**FINAL WORK PLAN
PILOT-SCALE EVALUATION OF
HYDROGEN RELEASE COMPOUND
FOR ENHANCED IN-SITU BIOREMEDIATION AT AOC 50**

**DEVENS RESERVE FORCES TRAINING AREA
DEVENS, MASSACHUSETTS**

RESPONSE TO COMMENTS

USEPA Comments Dated January 26, 2000

FIGURE 2

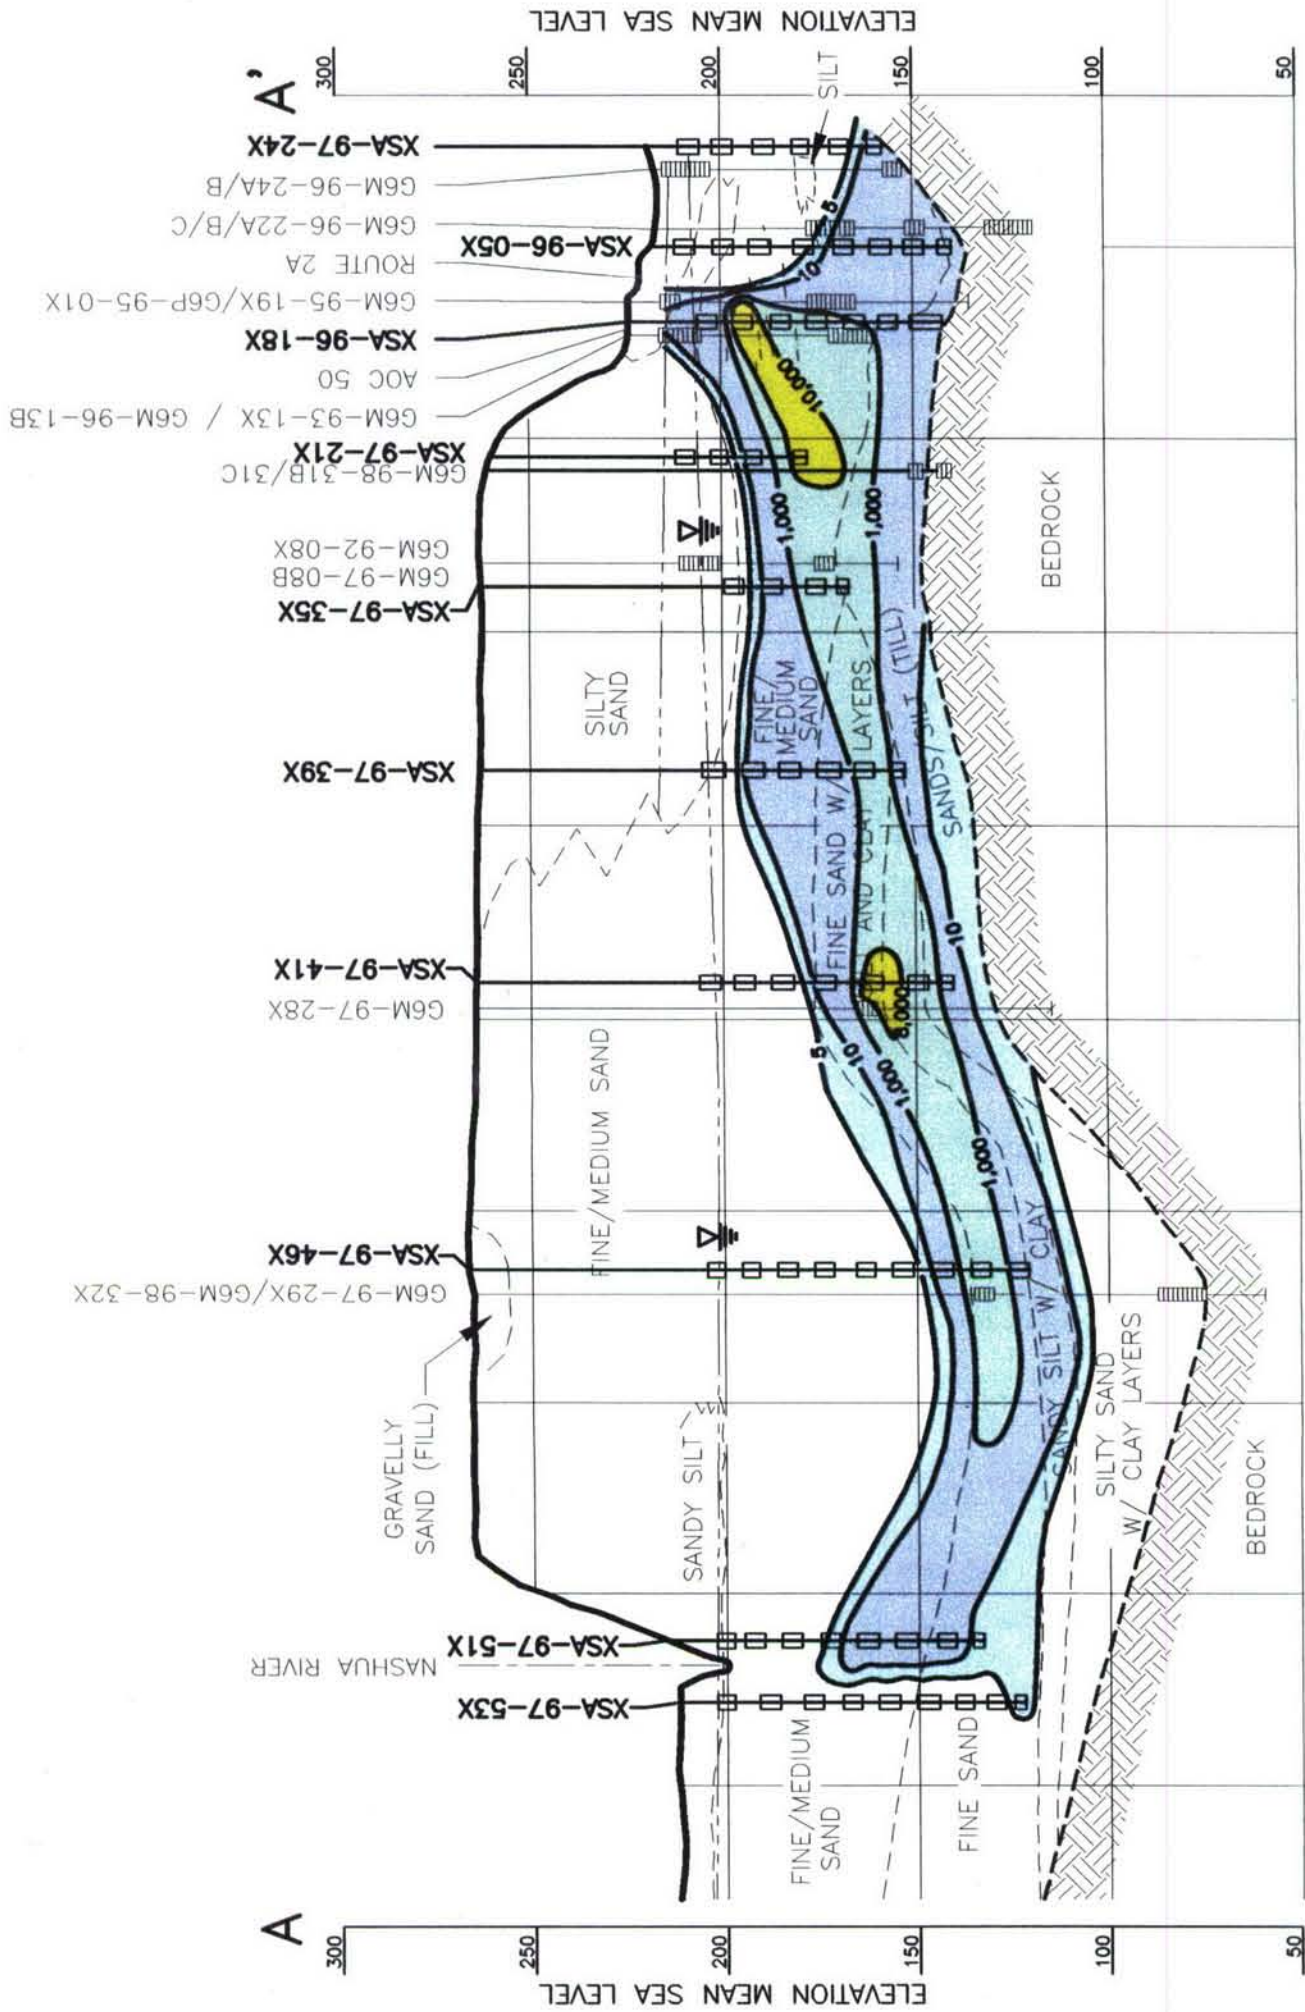
MADEP Comment No. 2; Section 4.2 HRC™ Injection: The Plan calls for injecting HRC™ over an interval of 140 to 120 feet below ground surface (ft-bgs) in the vicinity of XGM-98-32X. A review of the Figure 2 Distribution of PCE in Groundwater Along Cross Section A-A' shows the vertical distribution of the PCE plume to be from a depth of 115 to 160 ft-bgs. While the upper limit of the proposed injection interval appears to be proximal to the upper limit of the PCE distribution, the lower limit coincides with the lower PCE 1,000-ug/l concentration contour.

MADEP understands that interpreted geologic conditions at depth in this area consist of finer materials than that in the center or upper portions of the plume. However, these conditions based on the geologic history and boring logs, show a stratification of coarser and finer materials through which groundwater flow is predominantly horizontal. Historically, PCE has on one occasion been detected at depth in G6M-97-29X, which is placed with the screen just above bedrock. However, MADEP understands that the Army attributes the PCE detection to laboratory or sampling and handling error. The presence of PCE in this geologic media would likely be attributed to groundwater entering from an upgradient location, as opposed to vertical dispersion from above. Therefore, the HRC™ injected in a zone above will unlikely provide a beneficial impact to groundwater within or below this area. Therefore, MADEP recommends that the Army and its consultant evaluate the necessity of extending the vertical HRC™ injection interval deeper. Please provide a discussion for the selection of the HRC™ injection interval not to extend deeper into the aquifer to encompass more of the plume.

Response: The objectives of the pilot test are to assess whether conditions suitable for anaerobic degradation of PCE can be induced and to better characterize several process variables. Injection across the full thickness of the plume is not necessary to do this. There is no supposition that injection at the 120 to 140 ft bgs interval will treat groundwater at the 180 ft bgs depth of the G6M-97-29X screen.

FIGURE 4
HRC PILOT TEST LAYOUT
ENHANCED IN-SITU BIOREMEDIATION PILOT STUDY
DEVENS RESERVE FORCES TRAINING AREA
DEVENS, MA

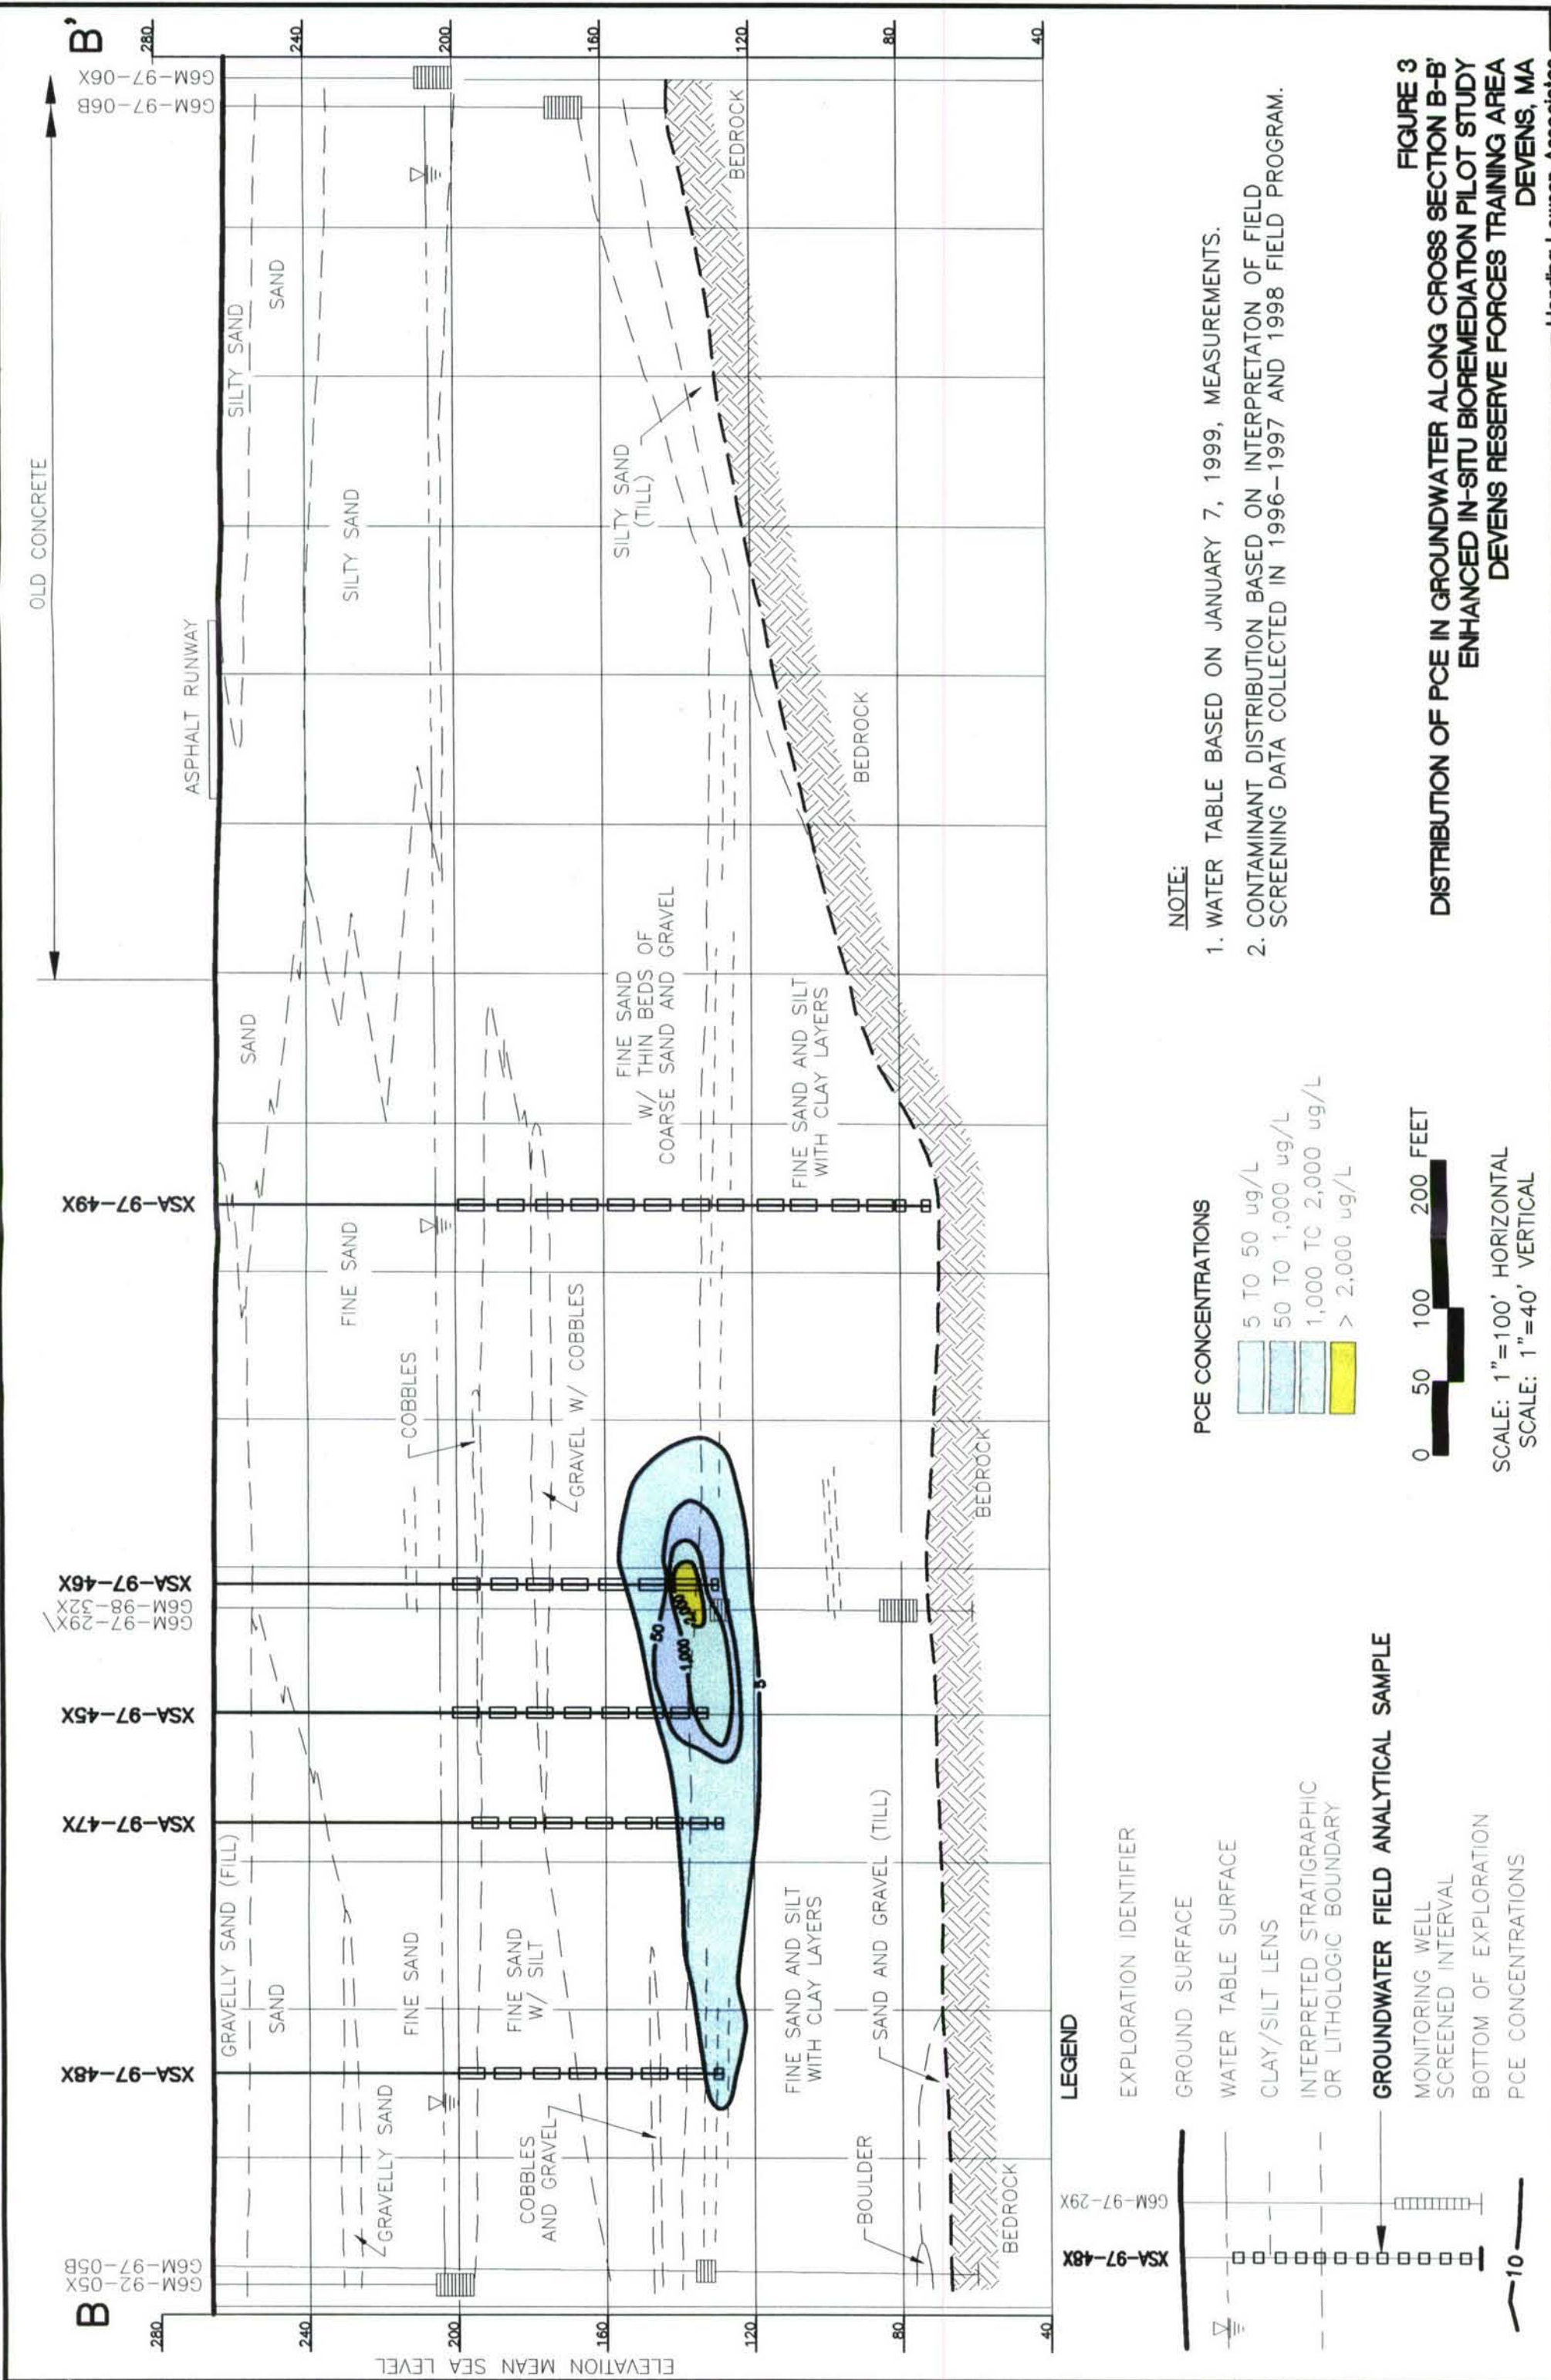
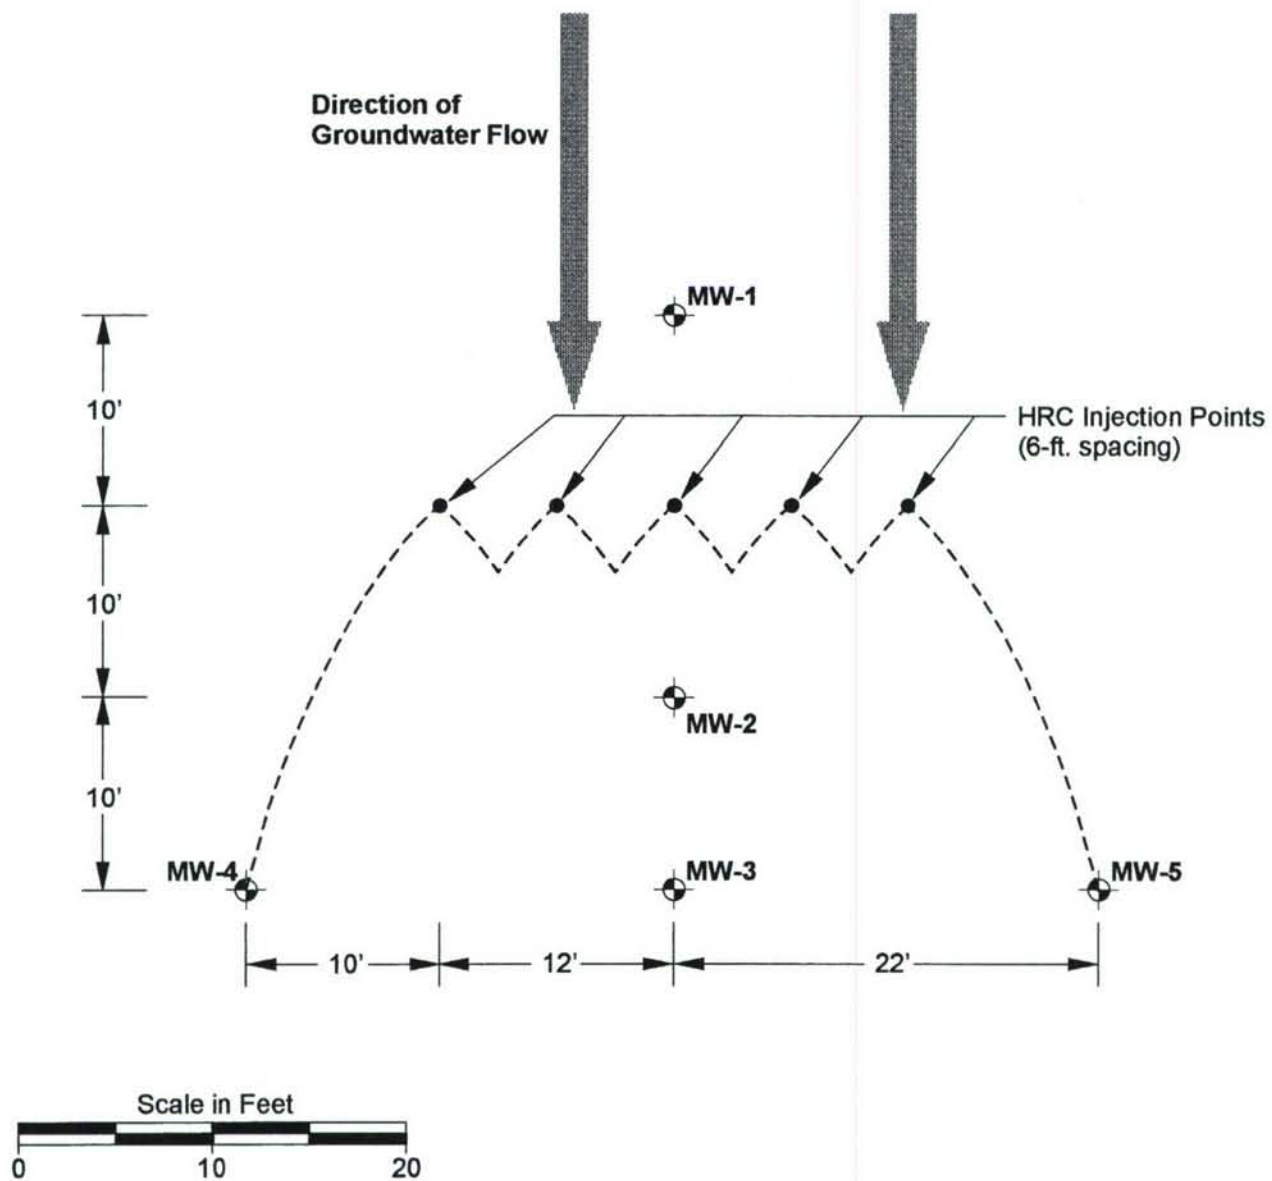
USEPA Comment No. 9; Figure 4: Two additional upgradient wells along a line parallel to the HRC injection points and intersecting well MW-1 should be included in this figure so as to completely assess the upgradient contaminant profile prior to groundwater entering the HRC treatment zone. The upgradient and downgradient monitoring wells and HRC injection points shown in Figure 4 should also be superimposed on Figures 1, 2, and 3 to show the plan view collocation of the HRC pilot test with the existing wells and PCE plume and to show in the vertical profile the depth of the well screens on those monitoring wells used in the pilot test. For example, one cannot know where well GM-98-32x is located in relation to the proposed monitoring wells and HRC injection points.

Response: Although more monitoring wells would provide increased contaminant profiling of upgradient groundwater, it is believed that the objectives of the pilot test can be met with the proposed monitoring wells. Groundwater samples will be collected from all the monitoring wells according to the schedule in Table 2. Considering the closeness of the monitoring wells (i.e., five wells in a 30- by 44-ft area), groundwater within the treatment zone should be well characterized. Further, limiting the number of monitoring wells will limit the disturbance of aquifer materials and potential introduction of drilling water.

The network of injection points and monitoring wells shown in Figure 4 will be located immediately north of G6M-98-32X and the service road that runs along the southwest edge of MAAF.

An in-text table has been added to Subsection 4.1 to document the depths/elevations with highest PCE concentrations. Proposed injection and monitoring well depths given in Subsections 4.2 and 4.3 have been calculated to intersect this high concentration interval. Because monitoring well G6M-98-32X was constructed with only a 5-ft screen, it is no longer planned to be among the primary monitoring wells for the pilot test.
